SERVICE BULLETIN

NO. SB-1

Model: A2

Subject: C-90-16F Continental Engine Breather Fitting

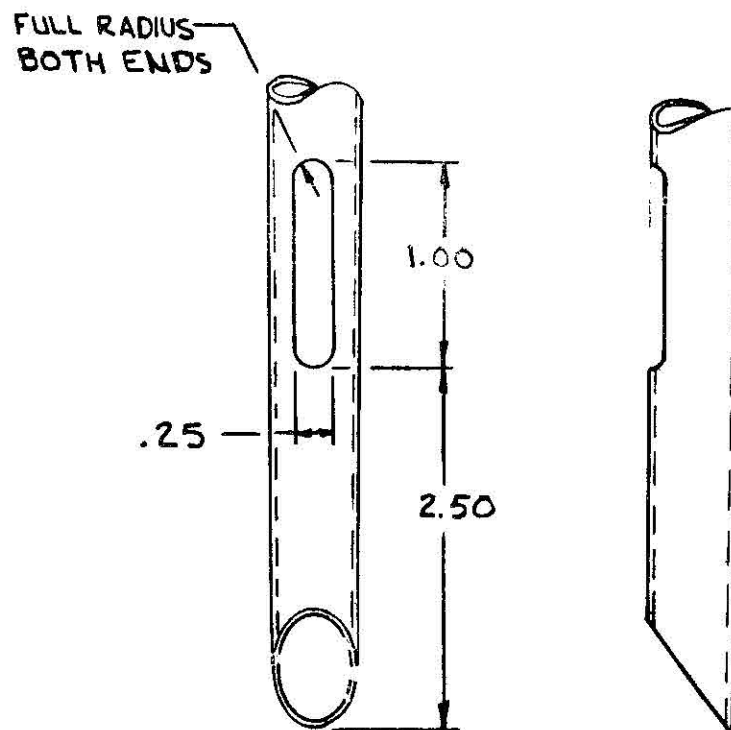
To reduce the amount of oil passing through the breather tube and exhausting on the under-side of the aircraft, Continental Motors Corporation has a newly designed engine fitting which extends further into the engine case. The extension places the opening away from the splashing caused by the vacuum pump drive.

This fitting is very easily installed at a time when the nose and top cowling is off for other reasons, or the old fitting may be removed and the new fitting installed, without removing either cowling, by removing the top portion of the fuel pump. This allows ample space for rotation of the fitting into the threaded portion of the engine case.

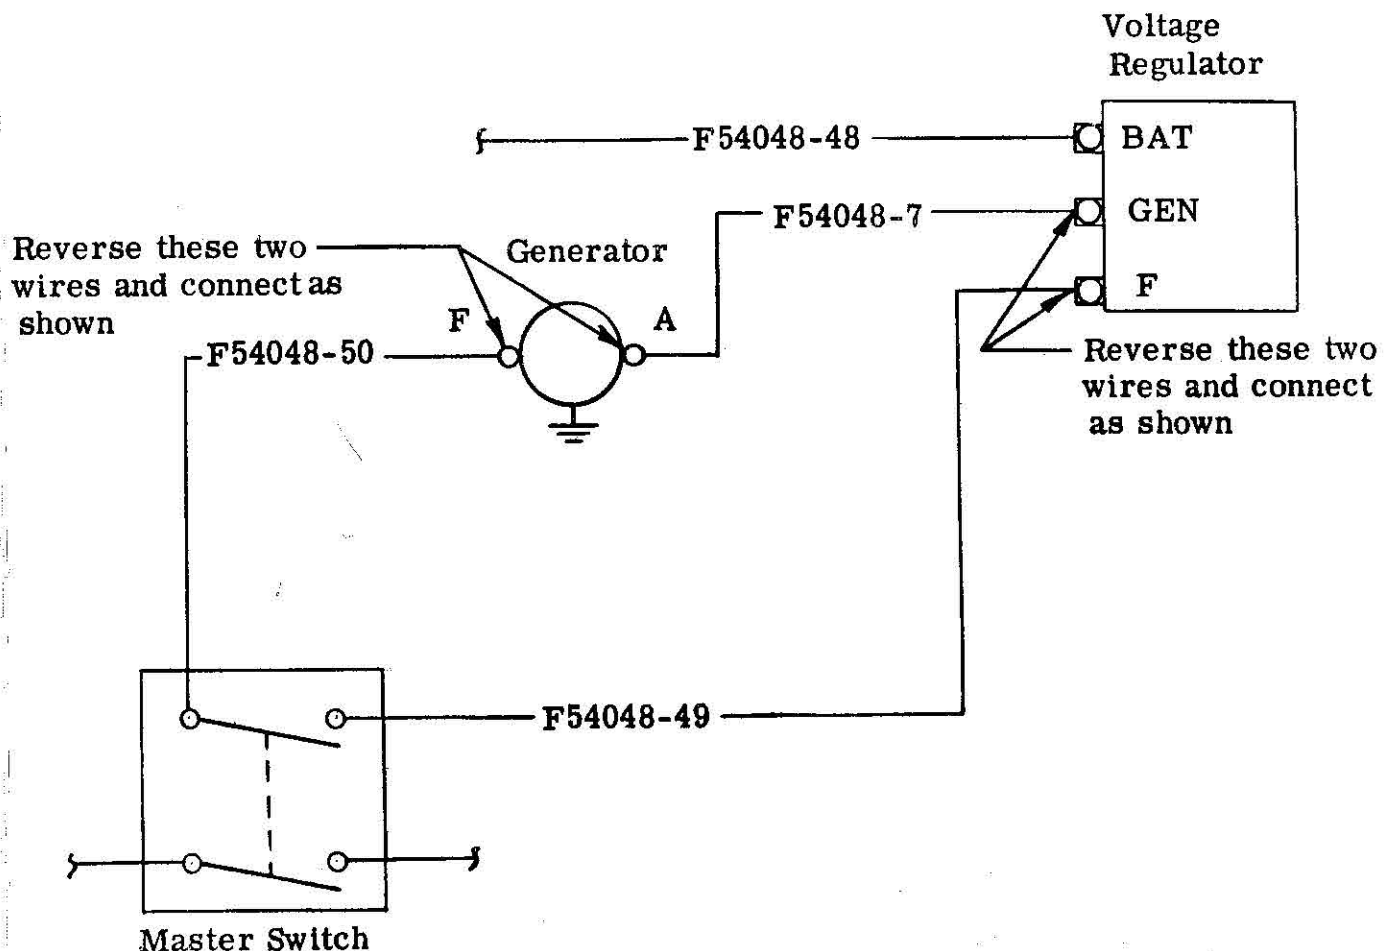
Subject: Wire Change in Generator to Regulator Wiring

A correction in the wiring on current models coming off the line has been incorporated to completely eliminate the remote possibility of overheating the generator if for some reason the master switch is turned off in flight for a prolonged period of time. The change consists of merely reversing the two wire connections on the generator and two of the wires on the voltage regulator. The final configuration should be as shown below.

Figure 1

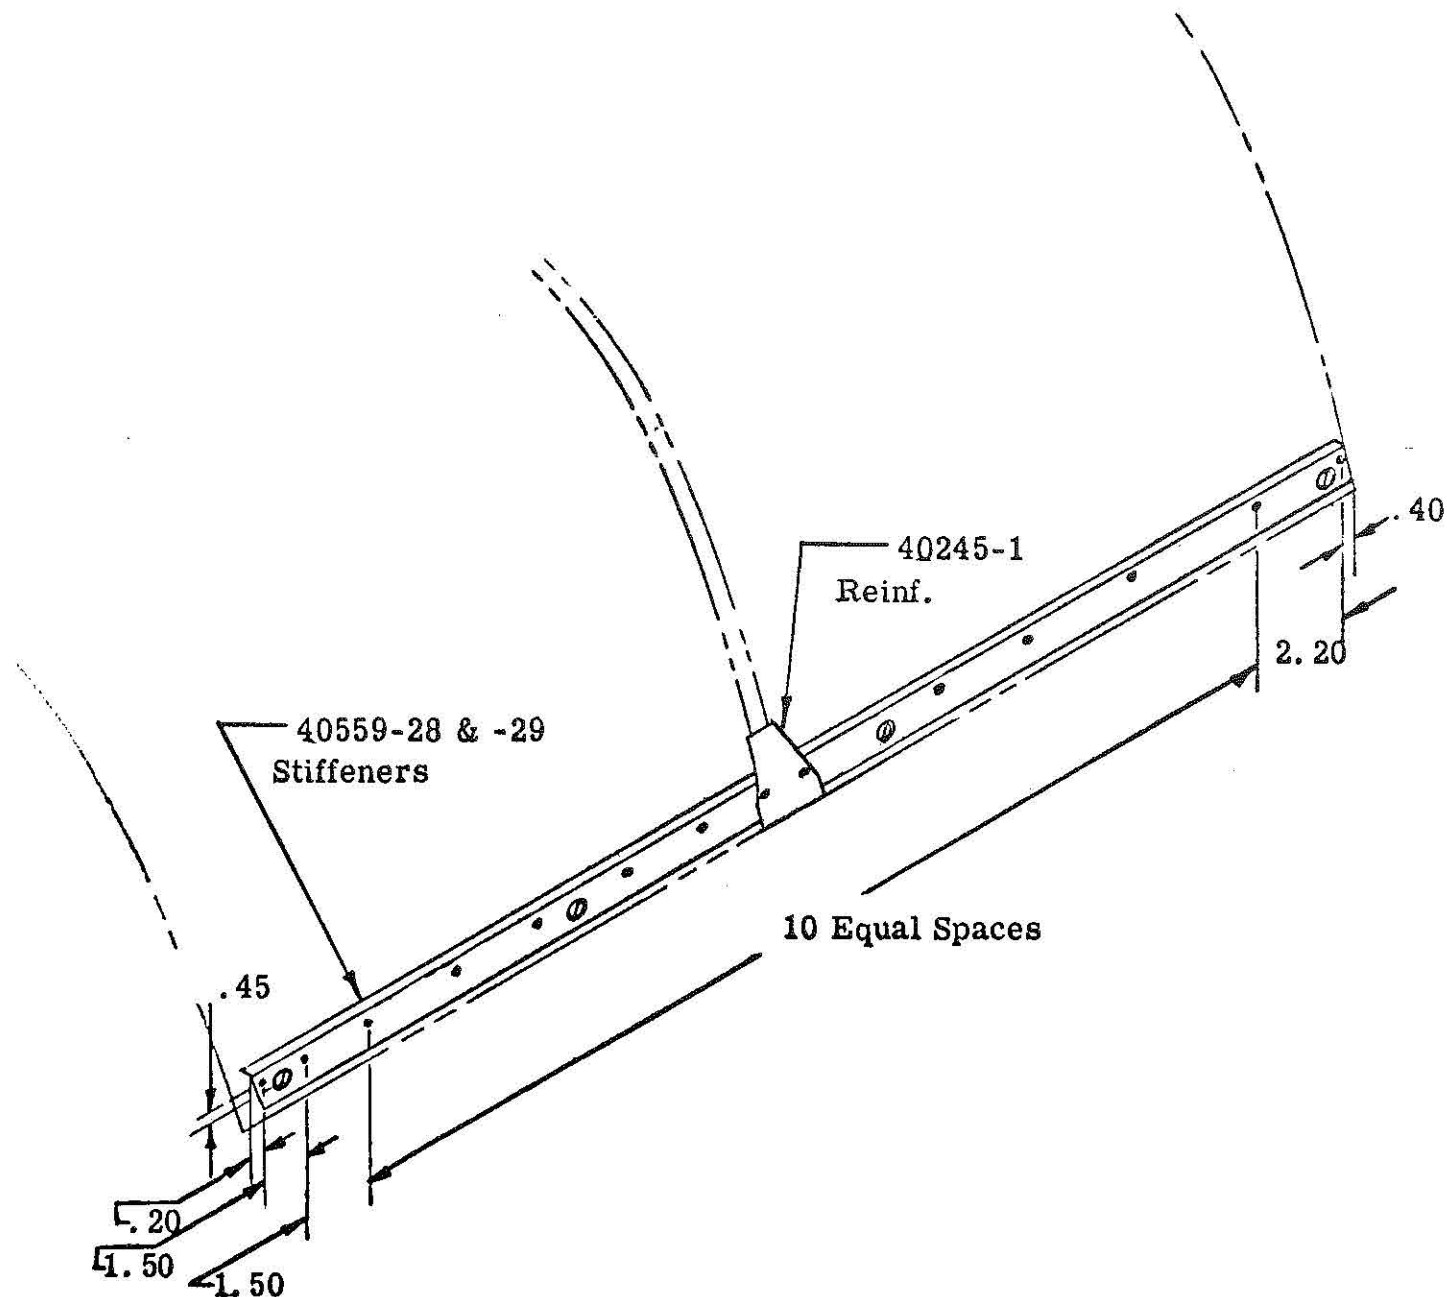
To preclude the possibility of skin cracking around the Camloc fasteners and reinforcement on the engine cowling doors, Alon recommends the following stiffener and reinforcement be added on each door:

1. Remove the four (4) Camloc fasteners on each door.
2. Drill out the two (2) rivets which secure the 40245 reinforcement to each door, and remove the reinforcement.
3. Install the 40245-1 reinforcement in same location and secure with two (2) MS20470AD3-4 rivets.
4. Install 40559-28 stiffener on the LH door, and 40559-29 stiffener on the RH door, aligning Camloc fastener holes in each stiffener with the holes in the door.
5. Per figure 1, drill fourteen (14) No. 40 (.098) holes through door and stiffener and secure each stiffener with MS20470AD3-4 rivets.
6. Reinstall the four (4) Camloc fasteners on each door.
7. Trim stiffeners, as required, to achieve a flush fit. Note: Do not crimp 40559-28 and -29 over the 40245-1 reinforcements.

Figure 1.

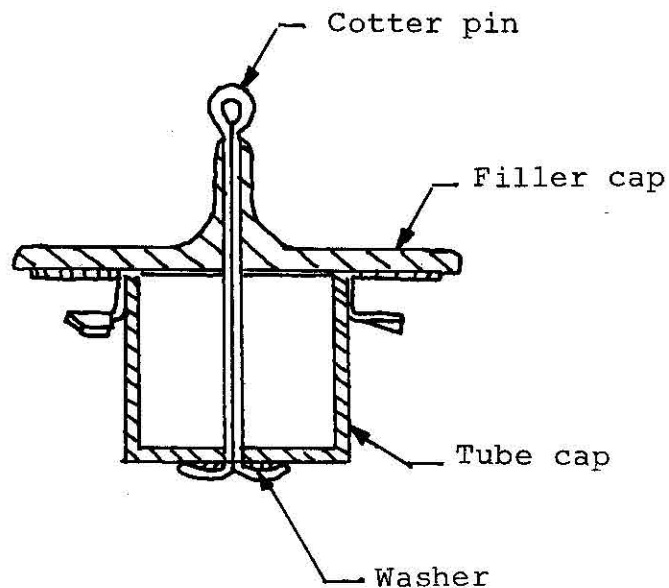
The following rework may be accomplished to eliminate the possibility of fuel overflow and in-flight siphoning:
(Refer to Figure 1)

- (1) Drill # 30 (.128) diameter hole through center of filler cap.
- (2) Install AN380C3-8 cotter pin downward through hole in filler cap.
- (3) Install 224 tube cap with open end against filler cap and cotter pin extended through the hole in the opposite end.
- (4) Install AN960C6 washer and bend tabs of the cotter pin flatly against washer and bottom of cap.

Figure I

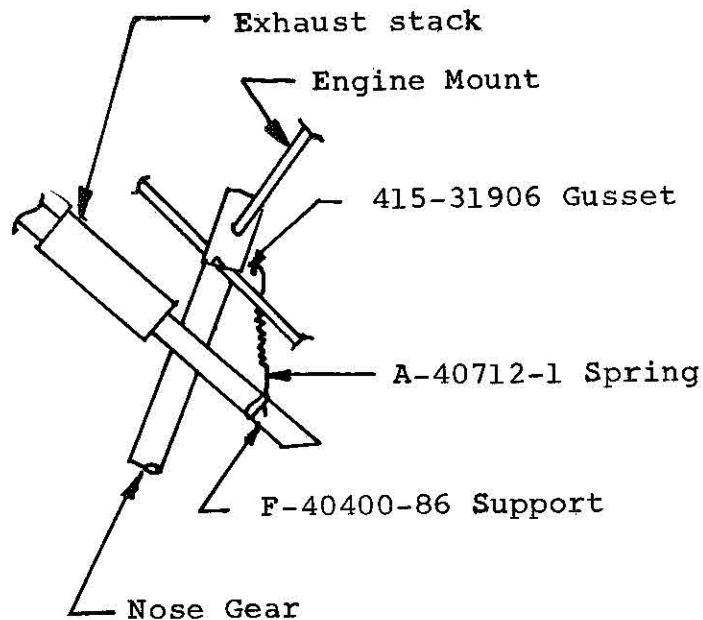
To provide a vertical support which will function in conjunction with the F-40400-86 horizontal support angle, install A40712-1 support spring as shown in Figure 1. Attach one end of the spring to the aft lip of the 415-31906 gusset portion of the mount assembly, and the other end of the spring under the lower flange of the F-40400-86 support.

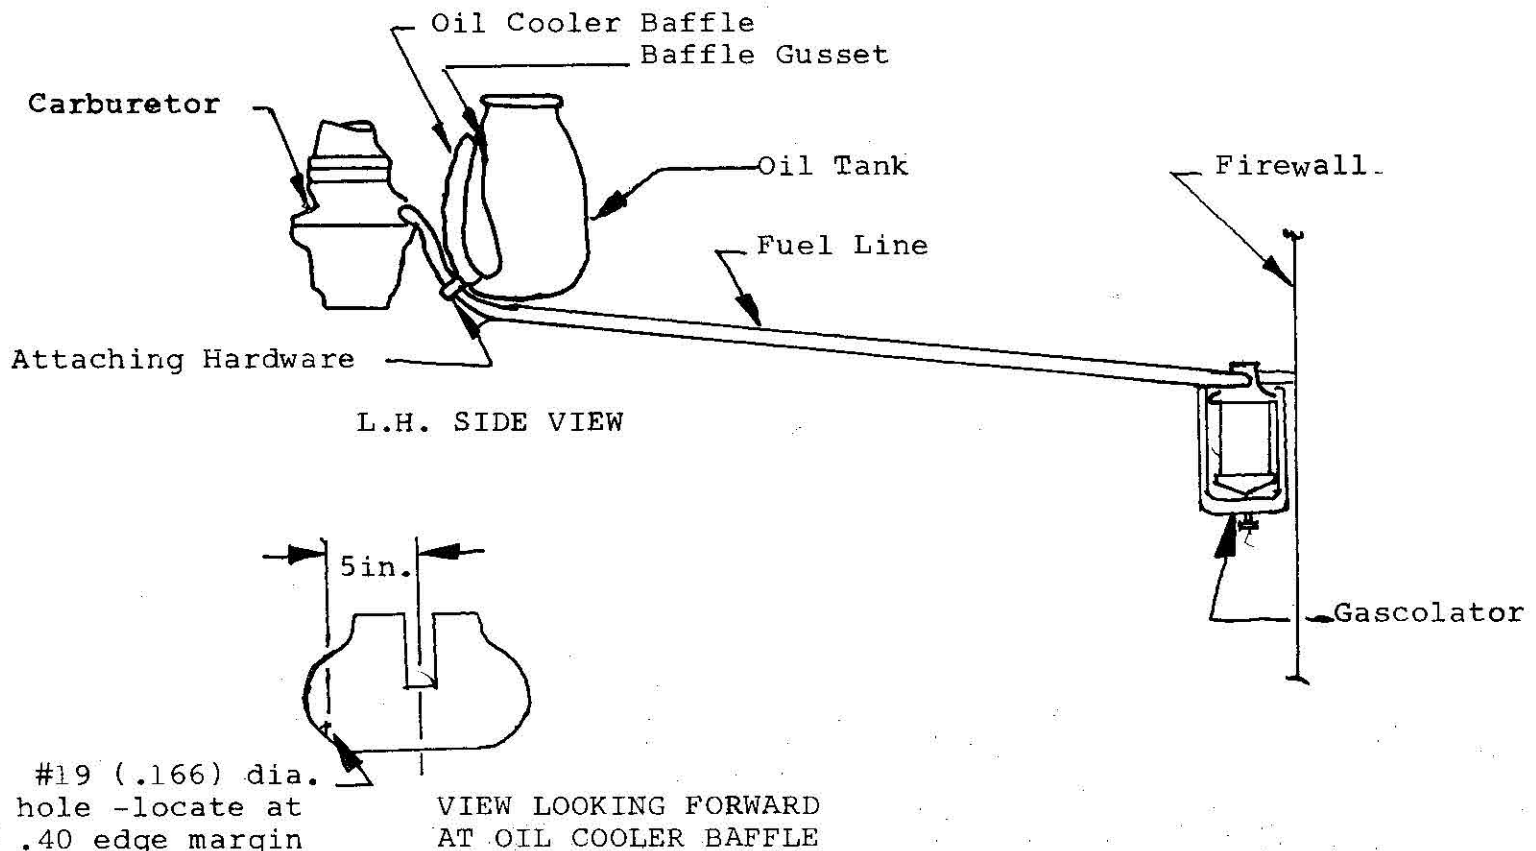
The following rework is to be accomplished by not later than the next periodic inspection to eliminate the possibility of a fuel line vapor lock occurring:

1. Drill a #19 (.166) diameter hole in the Oil Cooler Baffle Assembly as shown.
2. Reposition the 45 degree elbow in the Gascolator Outlet Port so as to point forward.
3. Remove clamps which previously secured Fuel Line to Engine Mount. These clamps will no longer be required.
4. Shorten the Fuel Line approximately three (3) inches and re-route down under the L.H. corner of the Oil Cooler Baffle Assembly. Attach Fuel Line to this Baffle using hardware which previously secured Fuel Line to the Baffle Gusset in hole added per item #1 above.

NOTE: Routing of this Fuel Line to be such that an "up-hill" path exists from Gascolator to Carburetor. Insure that no high or low spots in line are present.

Figure 1 VIEW LOOKING DOWN

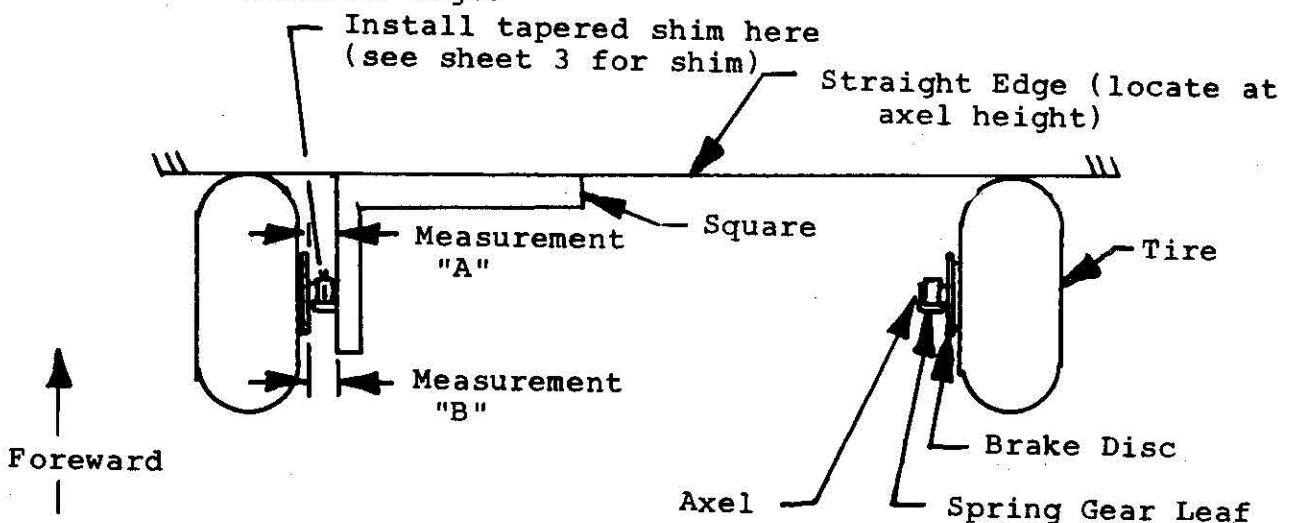
1. As shown in Figure 1, check alignment by placing a straight edge across the front of both main gear tires at axel height (both tire air pressures to be equal). See "Note" on page 2.
2. Hold a square against this straight edge and against the inboard end of the axel, measure the distance between the square and the inboard surface of the brake disc at (2) places (the extreme forward and aft edges) on both gear.
3. Subtract the smaller measured distance from the larger to determine the net misalignment dimension.
4. Locate this value on Line "C" of the chart (Figure II) and find its intersection with Line "A", drop straight down to Line "B" and at its intersection read the value on Line "C". This will establish the taper or amount to be added to the .003 to .010 basic thickness of the tapered shim at its thickest edge.

Measurement "A" - "B" or "B" - "A" = Net Misalignment Dimension

*Correct alignment to: straight ahead to .030 toe-in as measured per item #2 above.

Figure II

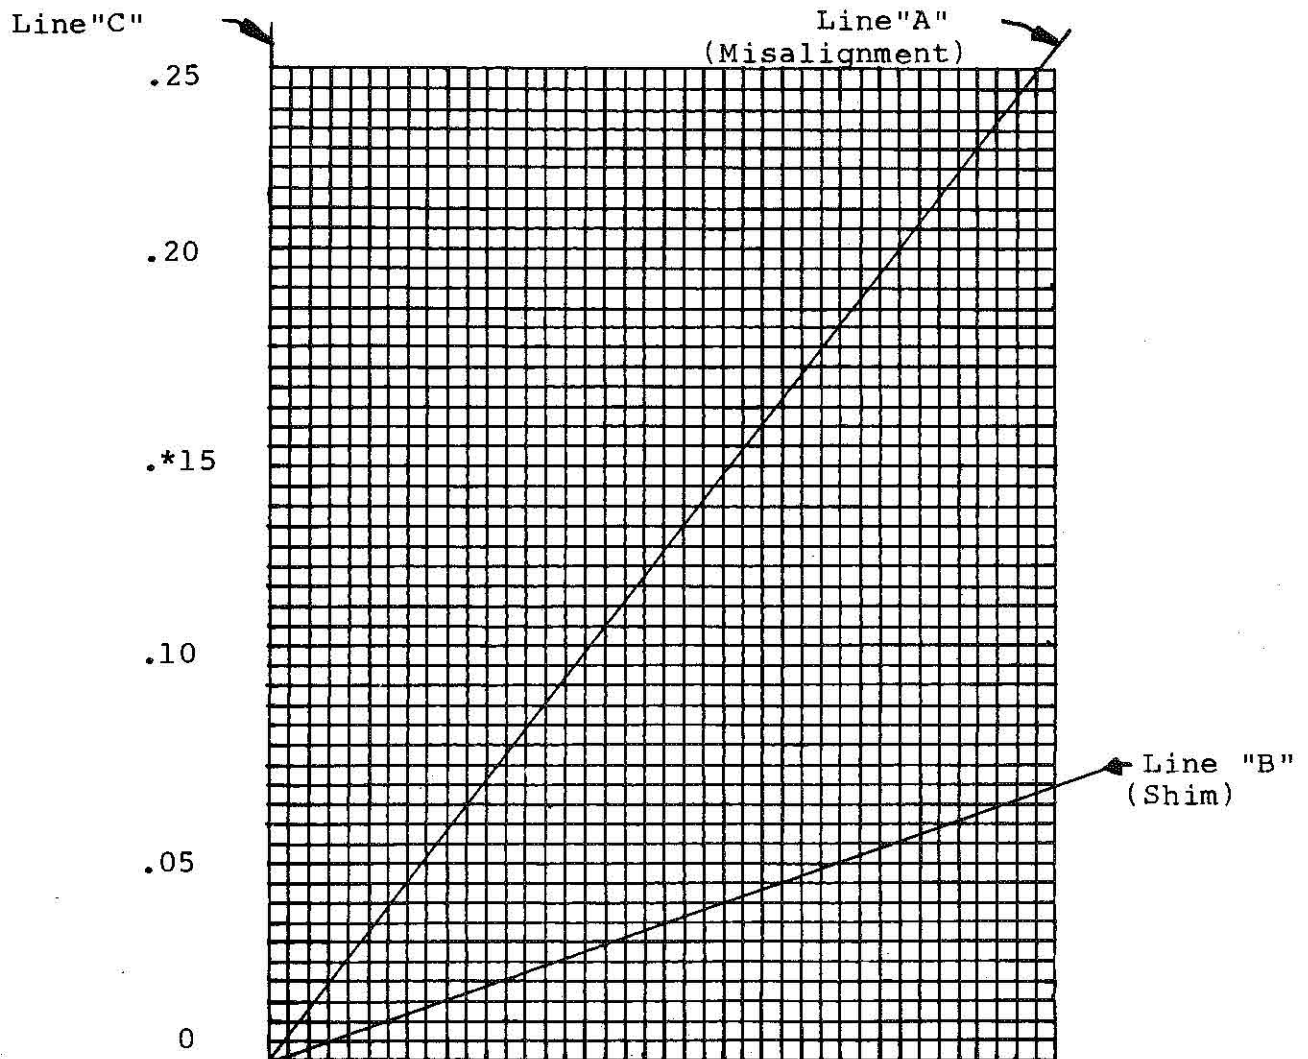
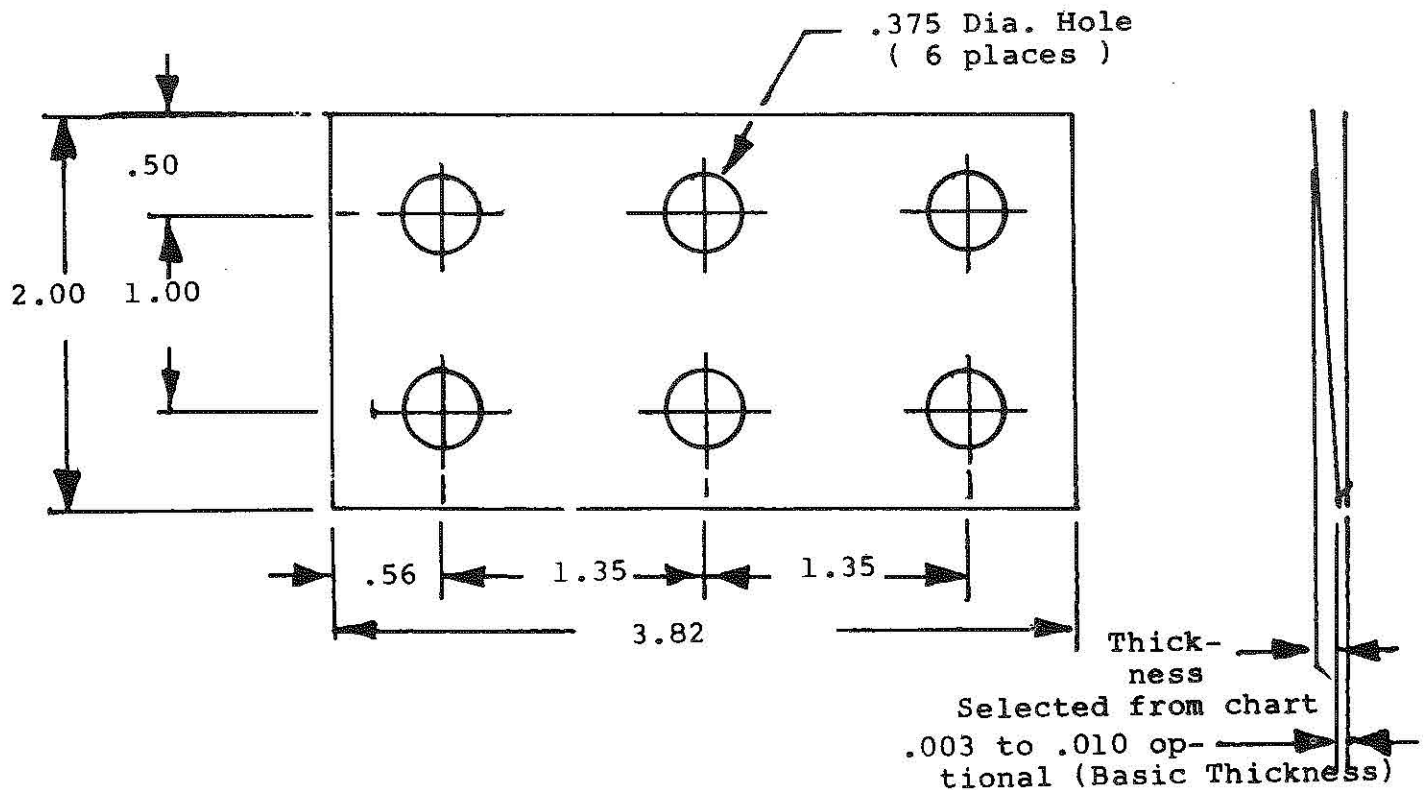
*If the misalignment net dimension is .15 or over, the (6) holes in the spring gear leaf must be line reamed (.375 dia.) to permit all surfaces to lie flush.

NOTE: Place each main gear tire on greased plates to insure correct alignment check.
